## MODERA BRIDLE TRAILS

07.17.23 | 21-019 | ©2023 WEBER THOMPSON

## OVERHEAD WEATHER PROTECTION COMPLIANCE (DRB RESPONSE 7)

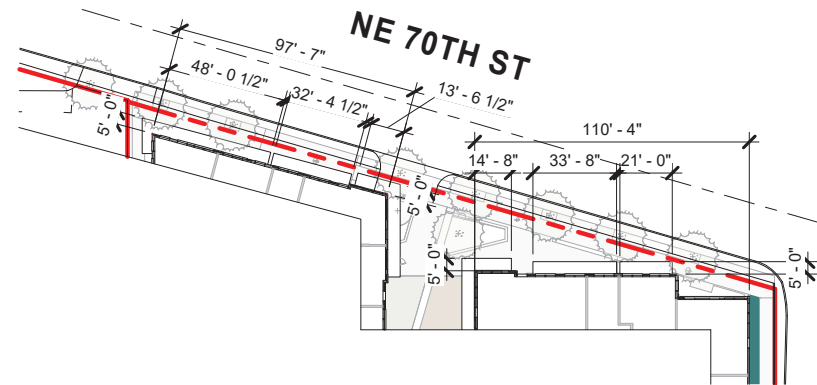
#### KZC 105.18.3.B - PEDESTRIAN ACCESS - OVERHEAD WEATHER PROTECTION

OVERHEAD WEATHER PROTECTION MUST COVER AT LEAST FIVE (5) FEET OF THE WIDTH OF THE ADJACENT WALKWAY AND MUST BE AT LEAST EIGHT (8) FEET ABOVE THE GROUND IMMEDIATELY BELOW IT.

FRONTAGE:  $97'-7" + 110'-4" = 207'-11"$   
 COVERAGE:  $48'-1/2" + 32'-4\ 1/2" + 13'-6\ 1/2" + 14'-8" + 33'-8" + 21'-0" = 163'-3\ 1/5"$

$$\frac{163'-3\ 1/2"}{207'-11"} = 78.5\% > 75\% = \text{COMPLIANT}$$

KZC 92.15.2 and KZC Plate 34 Q identify NE 70th as a Pedestrian Oriented Street where overhead weather protection is required. The project complies by providing 5' deep canopies over the adjacent walking surfaces for at least 75% of the building facade.

### STEP BACK @130TH AVE NE

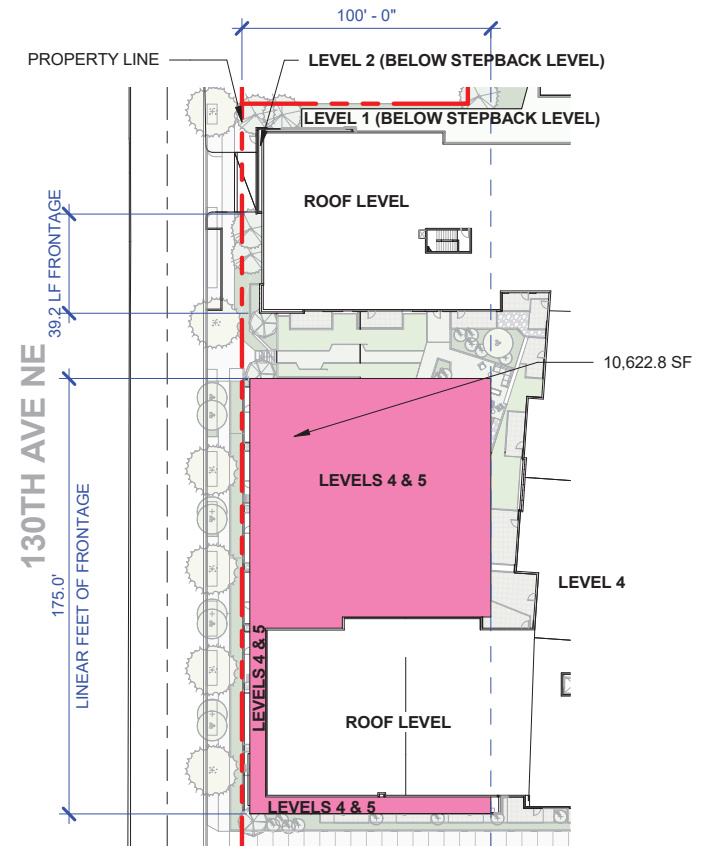
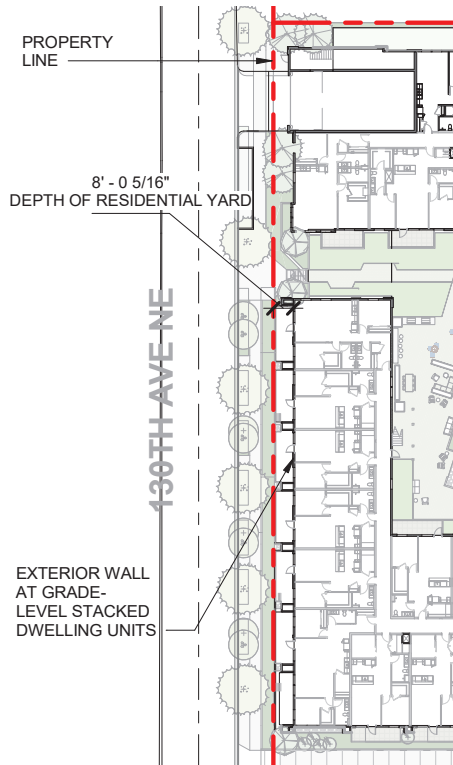
FOR ALL BUILDING FACADES FACING AND WITHIN 100 FEET OF THE ABUTTING RIGHT-OF-WAY, ALL PORTIONS OF A STRUCTURE GREATER THAN 3 STORIES IN HEIGHT, AS MEASURED FROM THE ABUTTING RIGHT-OF-WAY, SHALL BE STEPPED BACK FROM THE THIRD STORY BY AN AVERAGE OF 12 FEET (FROM 130TH AVE NE). THE REQUIRED UPPER STORY STEP BACKS FOR ALL FLOORS ABOVE THE THIRD STORY SHALL BE CALCULATED AS TOTAL UPPER STORY STEP BACK AREA AS FOLLOWS:

ATTACHED OR STACKED DWELLING UNITS LOCATED AT THE STREET LEVEL FLOOR ALONG 130TH AVENUE NE SHALL HAVE A MINIMUM 7 FOOT REQUIRED YARD. PER PLAN 2C/G1.02,

REQUIRED UPPER STORY STEP BACK AREA = LINEAR FEET OF FRONTAGE (NOT INCL PORTIONS OF THE SITE WITHOUT BUILDINGS OR FOR VEHICULAR AREAS) \* REQUIRED AVERAGE SETBACK \* NUMBER OF STORIES ABOVE THIRD STORY  
 = (174.9 FT + 39.2 FT) \* 12 FT \* 2  
 = 5,148 SF

PROVIDED STEP BACK AT LEVELS 4 & 5 = STEP BACK @ LEVEL 4 + STEP BACK @ LEVEL 5  
 = 10,622.8 SF + 10,622.8 SF  
 = **21,245.2 SF > 5,148 SF, MEETS REQUIREMENT**

YARD PROVIDED = **8' - 0 5/16" > 7 FEET, MEETS REQUIREMENT**

The design team has reviewed the setback along 130th with city officials and confirmed the project is compliant as shown with pilasters, unit patios, and similar exterior detail elements within the setback at grade.
